ADDENDUM NO. 2

FEBRUARY 28, 2024

Staunton City Public Schools, VA
Shelburne Middle School Additions and Renovations
CRA Project No. 3636

1 LOWER LEVEL NEW WORK FIRE ALARM PLAN - RENOVATION

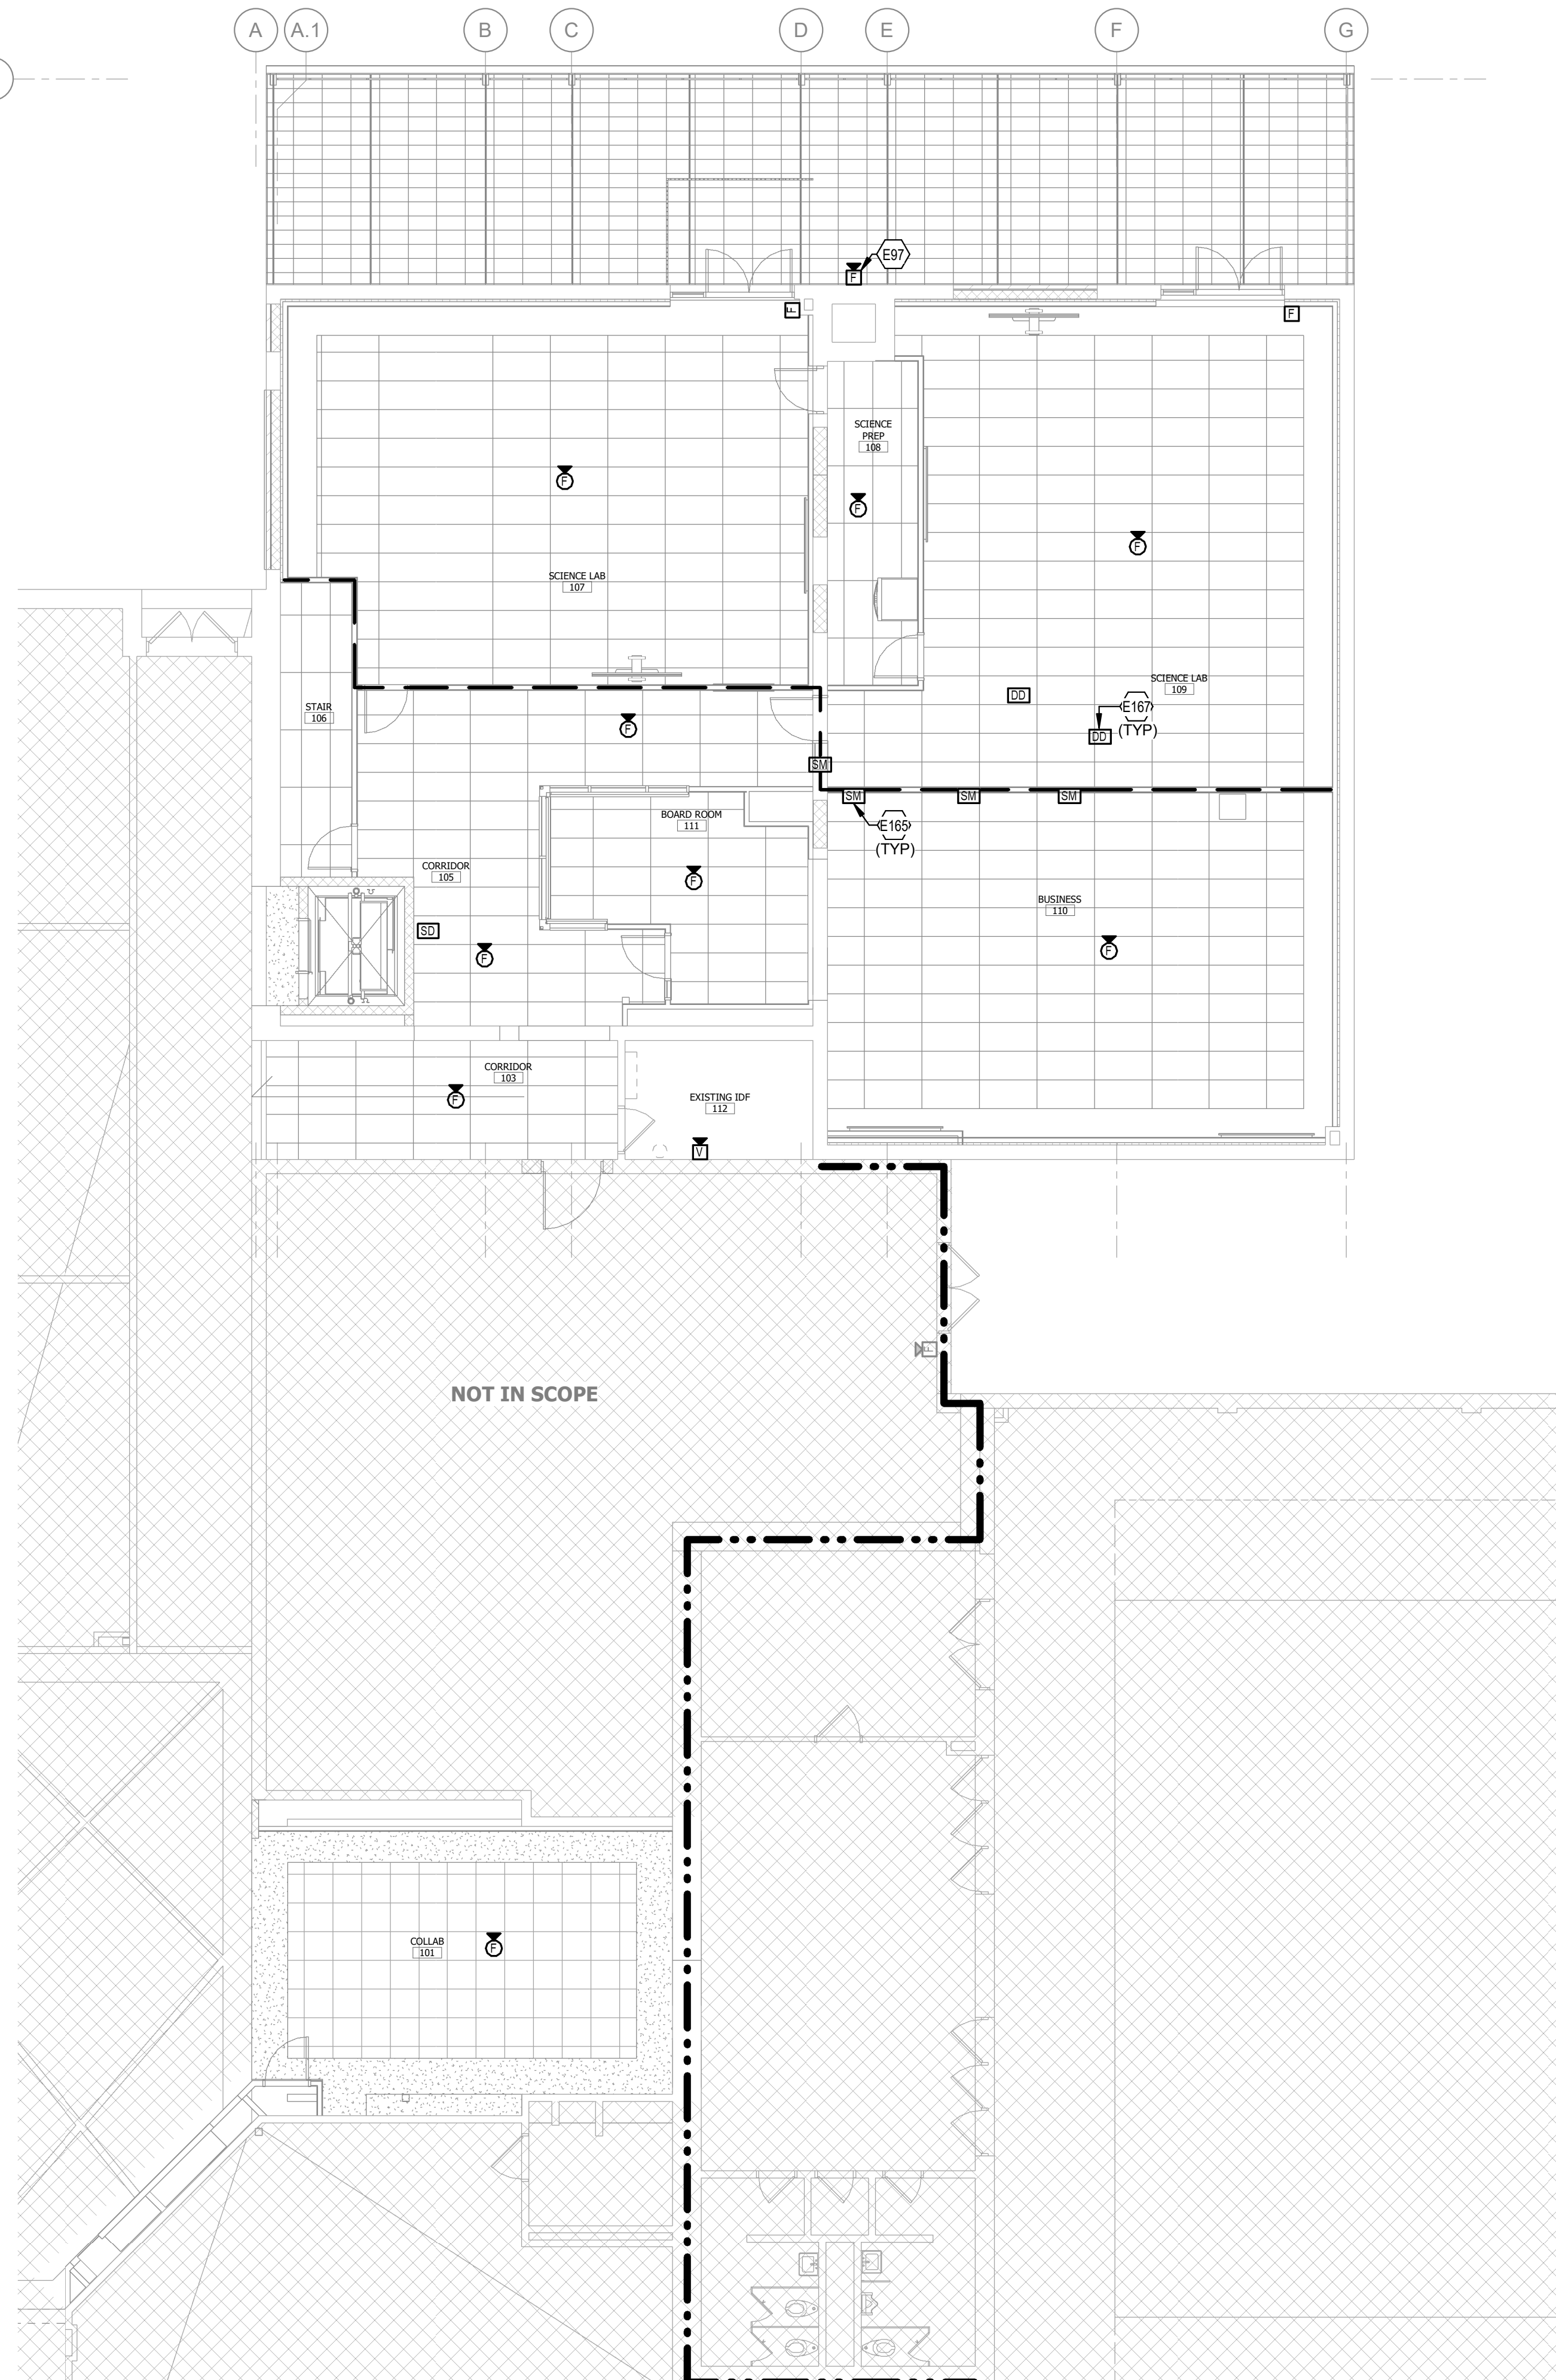
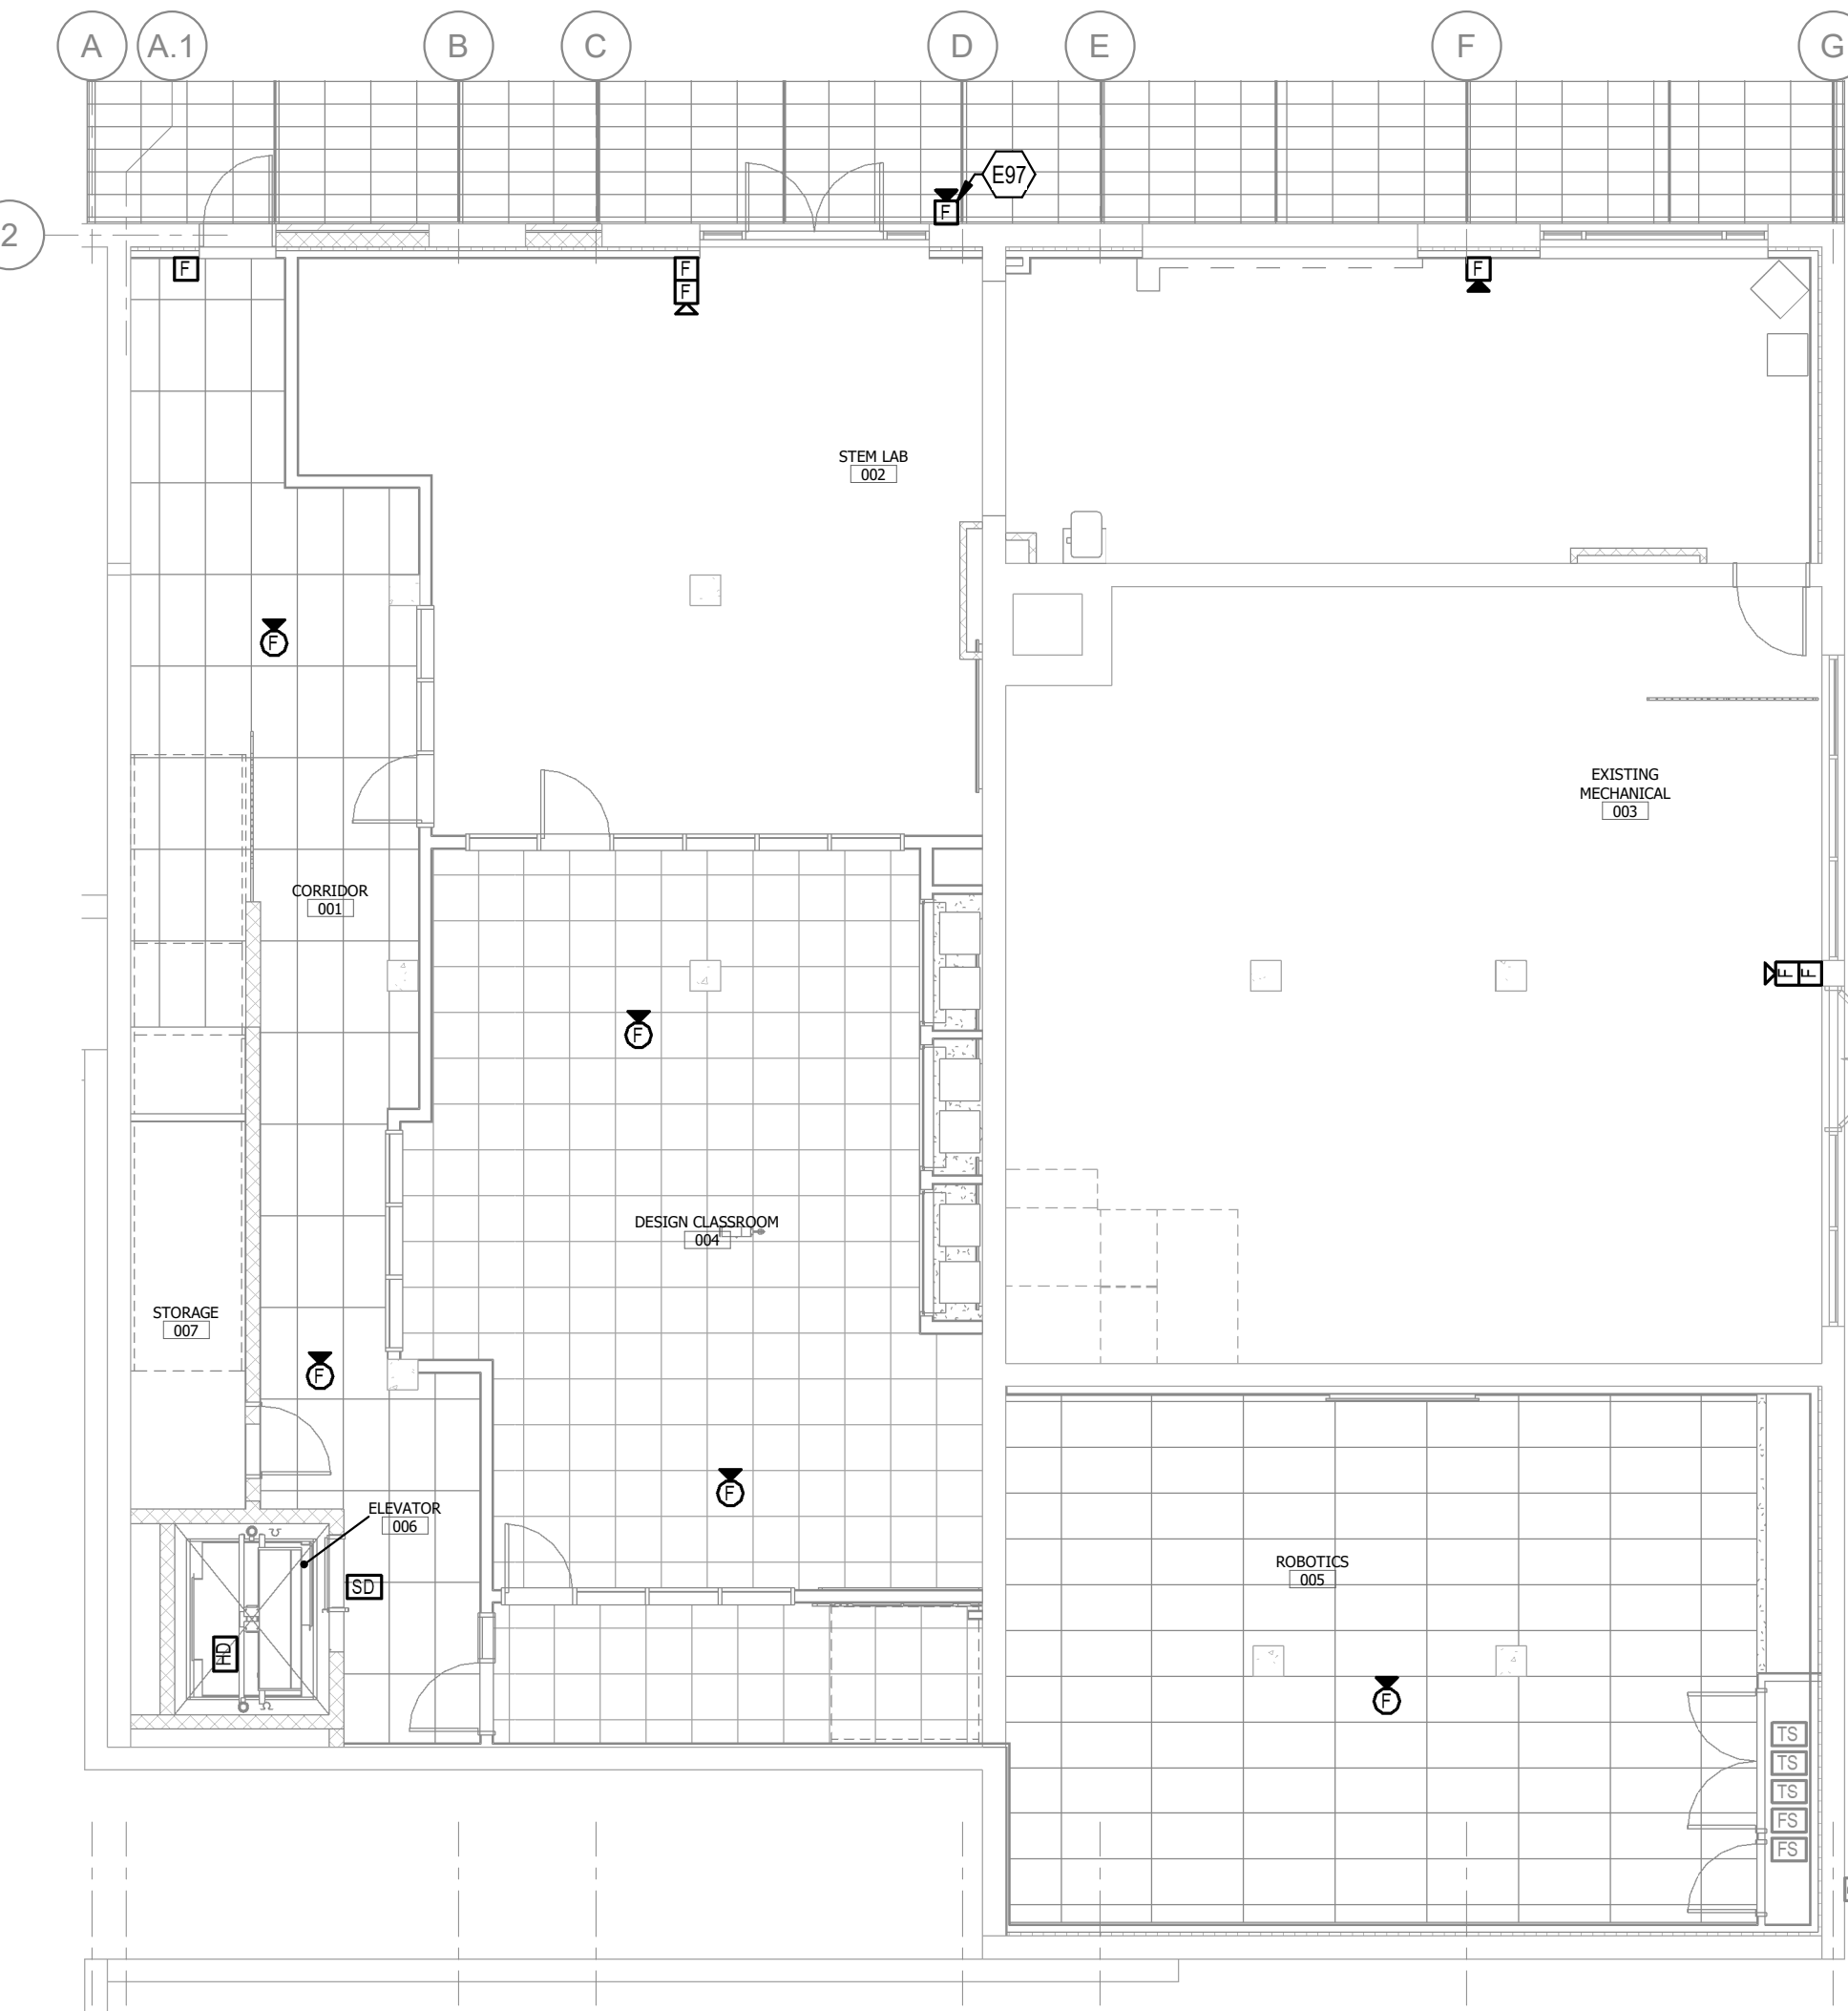
1. **DELETE** this sheet in its entirety and **REPLACE** with the attached sheet.
 - a. **REVISE** locations of notification devices in Admin 141 and Conference 143.
